**PLANNING AND ZONING COMMISSION AGENDA**

STAFF REPORT  
KETCHUM PLANNING AND ZONING COMMISSION  
REGULAR MEETING OF February 13<sup>th</sup>, 2017

**PROJECT:** Cutter Residence

**REQUEST:** Mountain Overlay Design Review approval for a remodel to an existing single-family residence located in the Limited Residential zoning district (LR).

**GRADING PLAN**

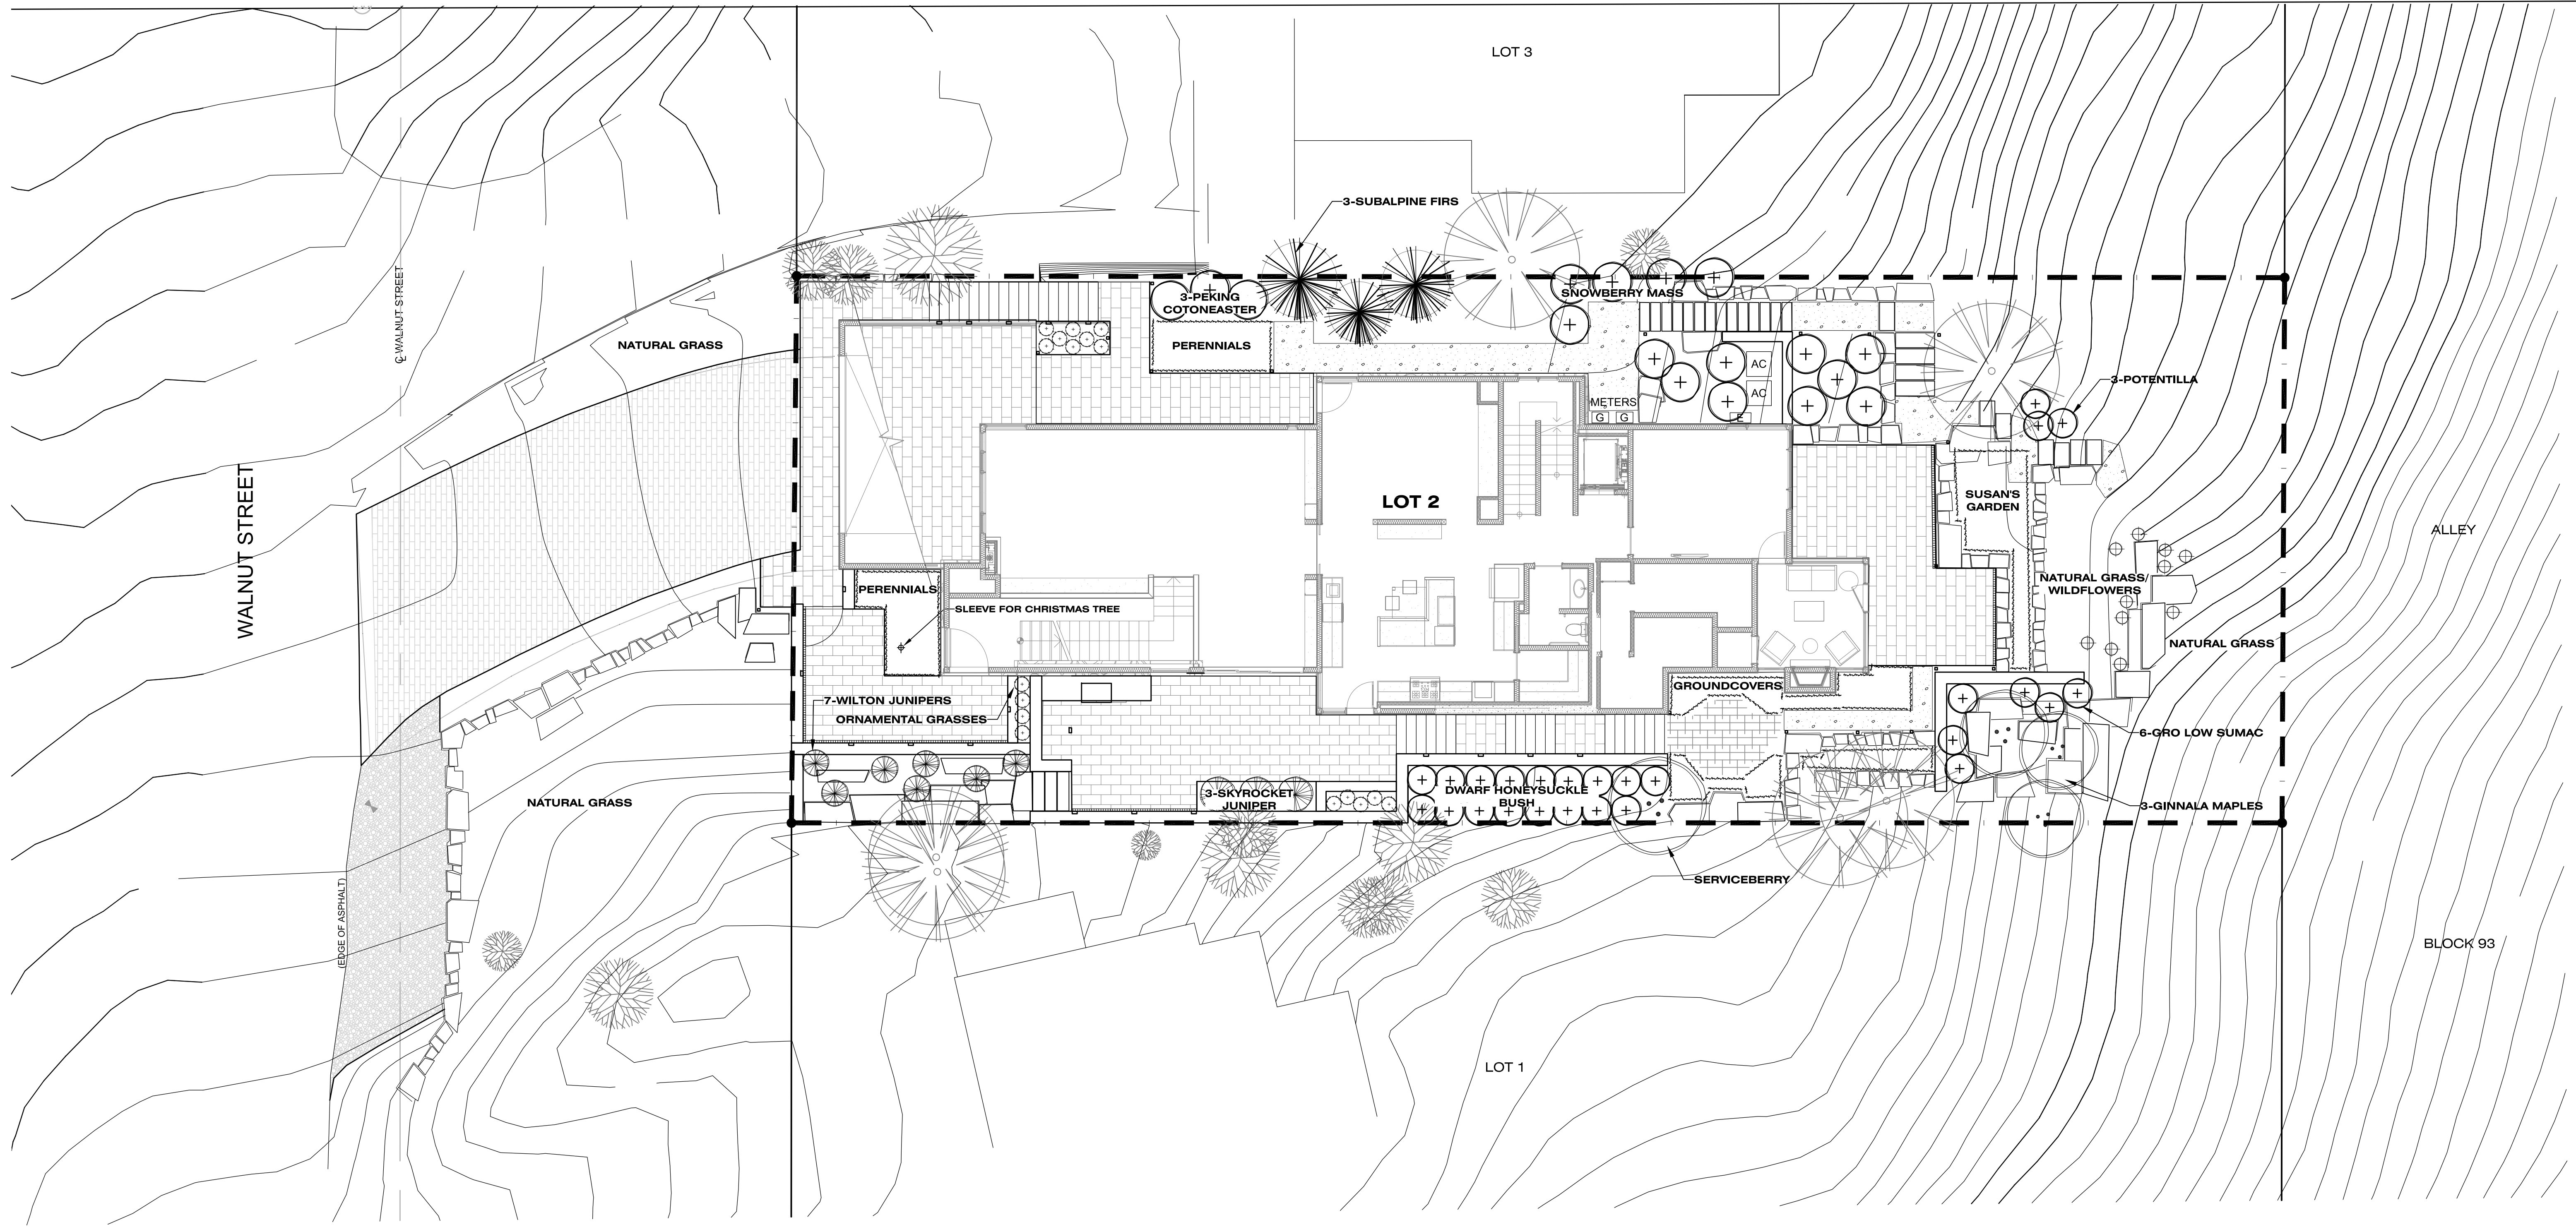
To meet drainage requirements and satisfy concerns from the Public Work Department, the garage floor may be dropped one foot (12"). This will accommodate a more gradual slope on the driveway and provide for a drainage system on Walnut that is acceptable to the Public Works Department. This modification is approved.

This drainage plan does depend on lowering the garage slab elevation 1' in order to keep the driveway slope manageable. Sloping down away from the existing street elevation to a drainage swale before sloping back up to the garage slab without lowering the garage slab would mean a driveway slope too steep to navigate in the winter. Thank you for suggesting this solution. It is a good way for the City to continue to improve the drainage along Walnut.
